Re: Project Application for Fabcot Pty Ltd (Woolworths) Retail Facility at Warnervale Town Centre

As the owner of lands adjoining the southern boundary of the subject application, Landcom supports the orderly development of the Warnervale Town Centre and therefore wishes to provide comments on the project application and supporting documentation that has been prepared in relation to this project. We also refer to the Director General's requirements for MP 10_0195 dated 1st December 2010 (DGR's).

See indicative sketch of road layout below.

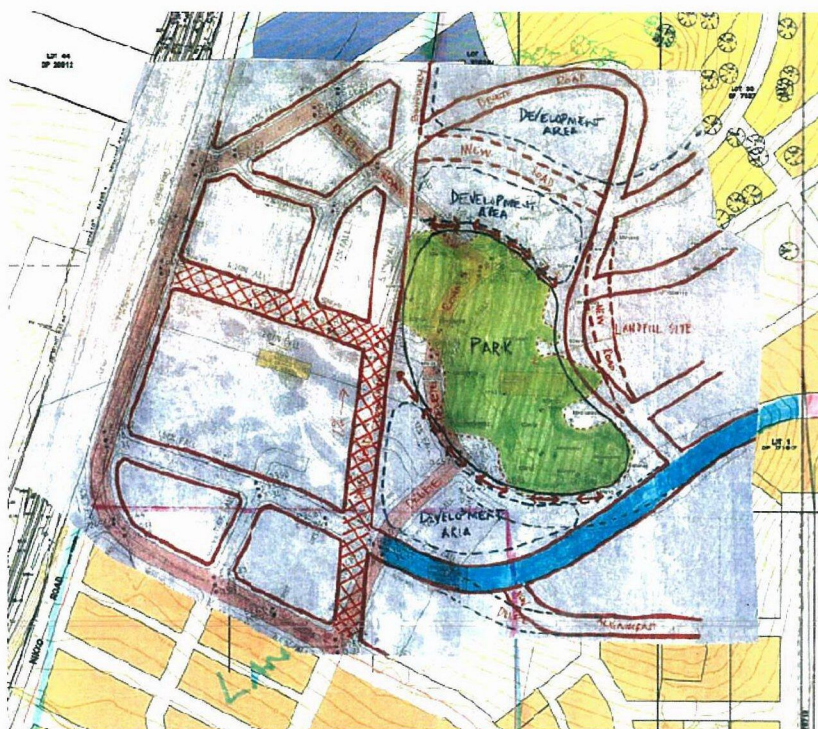
A major concern with the EA is that the whole documentation relies on an outdated road network within the retail centre. The original Development Control Plan proposed a ring road system that was later found to run through a large area of landfill that is owned by Council.

During subsequent analysis, Council has determined that it is economically unviable to disturb this material as the whole site would need to be remediated. That process involves removing all affected material off site.

For that reason Council and Woolworths have agreed on an alternate road system avoiding the landfill area, with that area eventually to be developed as a central park.

The implications of this change in the road network affect many of the matters under discussion in the body of the report. For example Section 2.2.4 Warnervale Design Analysis states "This contributes to the establishment of a smooth transition between contrasting elements of the high activity areas around the future Railway Station and the more casual nature of the Hill Top Park". This advice is now outdated.
